Planning Application Reference Number: VA04.324632

Applicant: Perigus Energy Ireland Midco Ltd.

Proposed development of a 220kV Air Insulated Substation (AIS) and Loop-in Grid Connection at Greenhills Solar Farm. Located in the townlands of Ballyneague, Ballydaniel, Knocknagappagh, County Cork.

Submission to Cork County Council on file reference 26/2133

Figure 16: Extract from Cork County Council 'Road Schedule Viewer' showing L7813 connecting to Inch Village. Dashed red line added to impassable section.

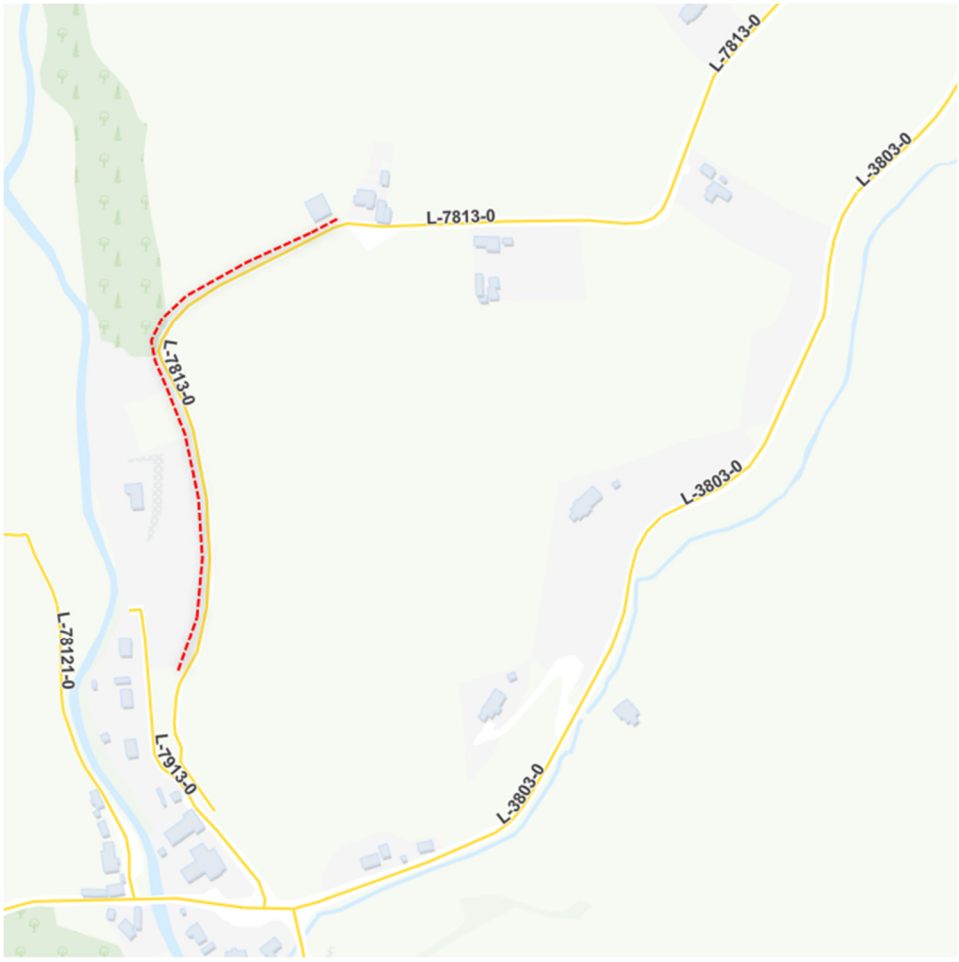
Drawing 7353-PL-DR-102 shows a section of a public road being fenced off, see Figure 15 & 16 below. Cork County Council should ensure that this area is not fenced off. A more proactive approach from the applicant would restore this area as a public passageway, not fence it off.

I ask Cork County Council to take proactive steps to ensure this route is passable for the benefit of pedestrians, cyclists and equestrian pursuits.

Figure 20: Extract from drawing 01.1, as submitted under CCC Planning retention file reference 25/6948

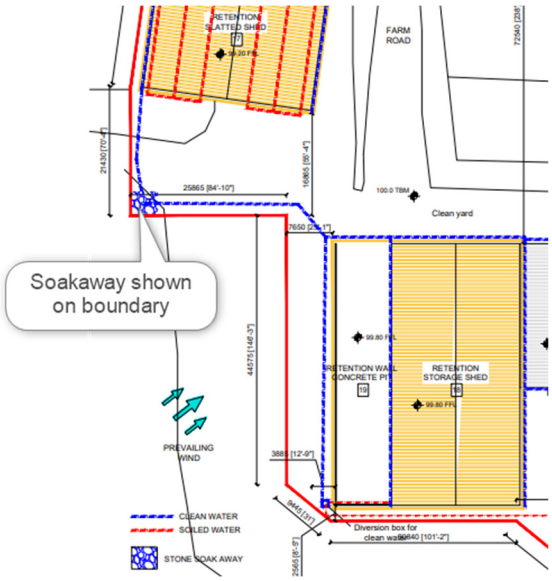
8. Unclear how surface water runoff/ silt will be dealt with here.
9. Existing open stream in this location – 20m drainage buffer not provided.
10. CCTV pole – Proposed field of view not provided. Unclear if this will breach our property.
11. Transformer units – proposed floor levels not provided – More appropriate siting would be further away from houses, with sound reducing measure incorporated.
12. Existing surface water soakaway not shown. (Soakaway location indicated on site layout drawing 01.1, as submitted under Cork County Council planning file reference 25/69/48)

Figure 21: Existing ESB infrastructure, not indicated on drawing

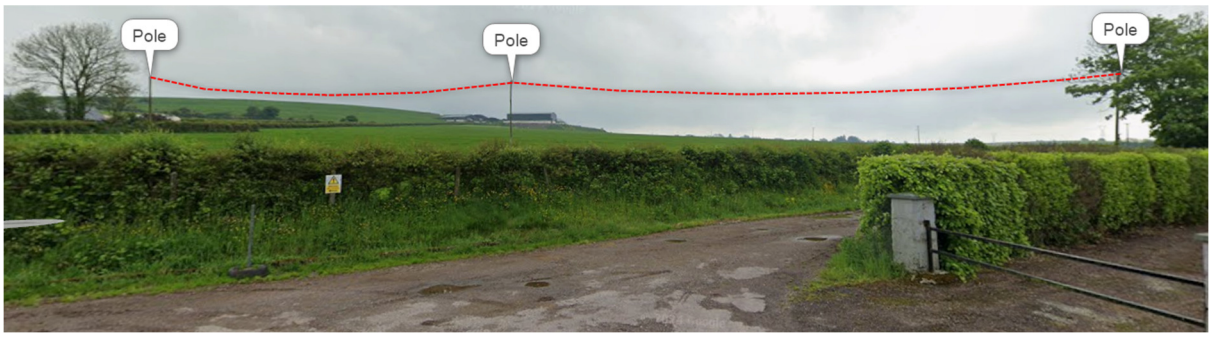
16. CCTV pole – Proposed field of view not provided. Unclear if this will breach our property.
17. Existing overhead ESB cable route and associated poles. These have not been indicated on drawing. We highlighted this during the consultation stage and were advised that solar panels would not be located under this overhead cable. Submitted drawings do not reflect this.

Figure 27: Issues identified on drawing 7353-PL-DR-104

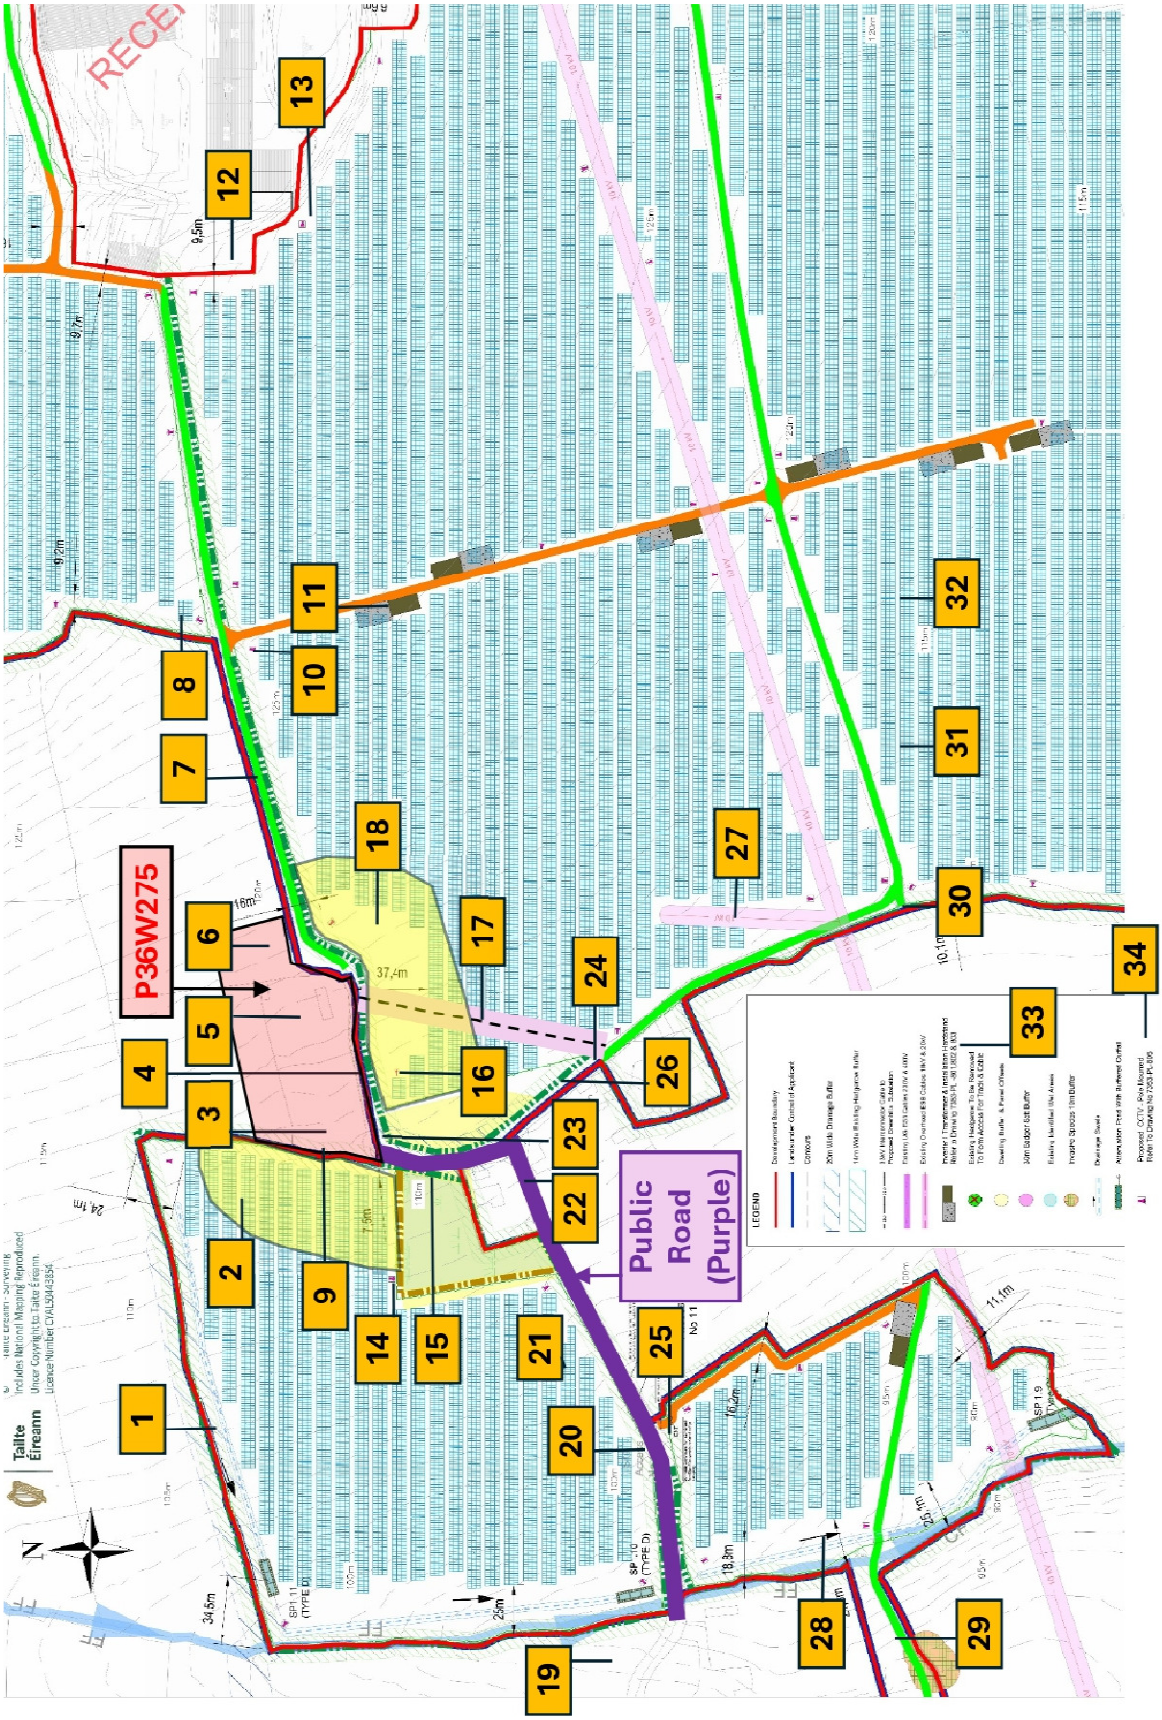
Drawing does not clearly reflect the existing buildings, septic tanks and percolation areas, bored wells or significant tree stands etc. I understand these to be validation requirements for any planning application.

The drawing is provided at a scale of 1:1000, not the standard 1:500 scale for site layout plans. This has impacted my ability to review the details of this proposal.

It is unclear if ground contour level lines on the drawing are existing or proposed.

1. Drawing notes 20m Wide Drainage buffer – There does not appear to be an existing drain in this location.
2. Insufficient set back allowed from our property. Less overbearing set back marked up, indicated in yellow.
3. Existing Mature Copse, Septic Tank and Percolation area not indicated on drawing.

4. Unclear if works are proposed between red line boundary and 'Retained & Enhanced Hedgerow'. Unclear if this area will be used for vehicular traffic.
5. Existing building misrepresented.
6. Existing building not shown.
7. Unclear why there is an 'Existing upgraded track' in this area. Is does not appear to serve the development. Also note that drawings have not been provided to show what 'upgrade' works are proposed.
   Dust raised from this track currently injures our residential amenity. Application documents do not include for dust mitigation measures here.

13. Unclear if ground contour level lines are existing or proposed. The contour lines shown in this area differ significantly to existing topographical conditions on the ground. It is unclear if significant excavation is proposed to lower the ground level to its natural level, or if panels will be elevated above 3-4m above the existing ground.

14. CCTV pole – Proposed field of view not provided. Unclear if this will breach our property.
15. Existing gate in this location. Drawing seems to suggest that this existing gate will be closed by fence as indicated on drawing. Confirmation of same should be provided.

18. Insufficient set back allowed from our property. Less overbearing set back marked up, indicated in yellow.
19. Existing mature trees not indicated.

20. Existing gate in this location. Drawing seems to suggest that this existing gate will be closed by fence as indicated on drawing. Confirmation of same should be provided.
21. There appears to be no access shown to this field. How will construction access be provided? How will Operational Access be provided? How would service connections be made.
22. Significant surface water run off down road from the site. This is a nuisance and needs to be resolved. Freezing conditions create a significant health and safety risk.

24. Existing gate in this location. Drawing seems to suggest that this existing gate will be closed by fence as indicated on drawing. Confirmation of same should be provided.
25. Insufficient sightlines in this location. Vehicles approaching from the west cannot safely see vehicles approaching from the east.
26. Existing Drain in this location – 20m wide drainage buffer not provided
27. North/ south leg of existing overhead line does not appear to exist on site. Is this a proposed element? The purpose is unclear.

31. Unclear how high solar panels will be above the ground, particularly on hilly area. Drawing PL-501 shows solar panel table array sitting idyllically on flat ground

33. Drawing Note: *'Inverter / Transformer & Installation Hardstand. Refer to Drawing 7353-PL-801,802 &803'*
    Drawing 801, 802 & 803 relate to fencing/ gate details. Misleading to the public.

34. Drawing Note: *Proposed CCTV – Pole Mounted Refer to Drawing No 7353-PL-805.*
    Drawing 805 relates to a construction compound. Misleading to the public.
